FIELD SERVICE BULLETIN

FSB Number: LVCCFSB2004-151
Author: Max Dekirmandjian / Hien Huynh
Date: July 8, 2004
Total No. of Pages: 4
Subject: **GSM E398 – Poor audio, Earpiece-Echo**
Model Affected: E398
Level of Repair: 3

Refer to the photos & part number below to aid in distinguishing between the old & new keypads:

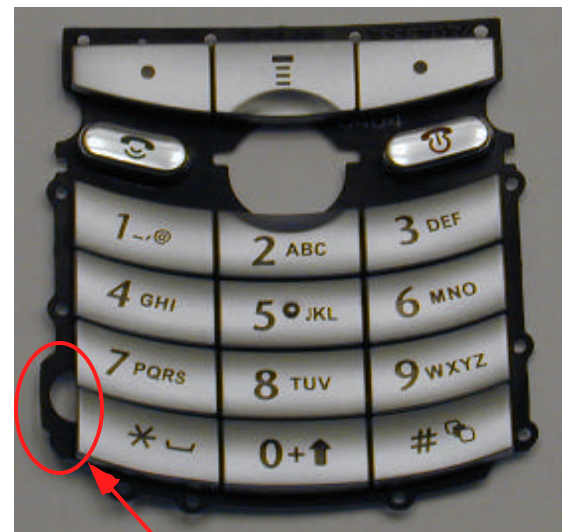
Development Engineering identified that these keypads have a poor seal around the mic. Development Engineering requested that for a echo related failure, if it is required to replace the front housing with a 1589893Nxx Rev B along with the 3-key keypad P/N 388303Yxx (Refer to the tables below for the correct suffix).

Note: Both the front housing & keypad needs to be replaced to fix the echo issue.

Replace the front housing & keypad on E398 returns with a MOM of June 2004 or earlier that have Mic/TX Audio related customer complaints. Refer to the tables below for the correct part numbers.

NEW KEYPAD PART NUMBER	LANGUAGE
3888303Y03	ENGLISH
3888303Y04	HEBREW
3888303Y05	RUSSIAN
3888303Y06	ARABIC
3888303Y09	THAI
